N6953A-02

Modification Recommended Service Note

N6953A – Advanced Power System, DC Power Supply, 60V, 16.7A, 1000W

The Problem – Charge Present on the AC terminal when unplugging the unit.

Figure 12

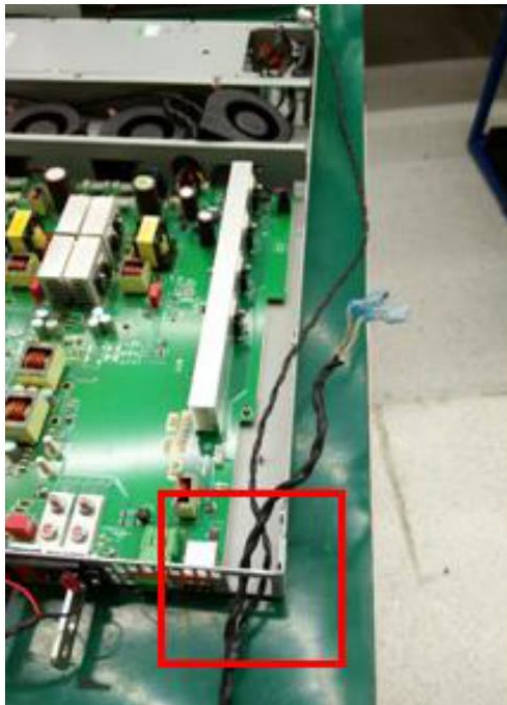
12. Insert the AC line cable (5190-4495) into chassis as shown in

13. Figure 12.

New AC line filter (5190-4495) with 15GENG3E-R is used to replace the existing AC line filter to optimize the discharge time.
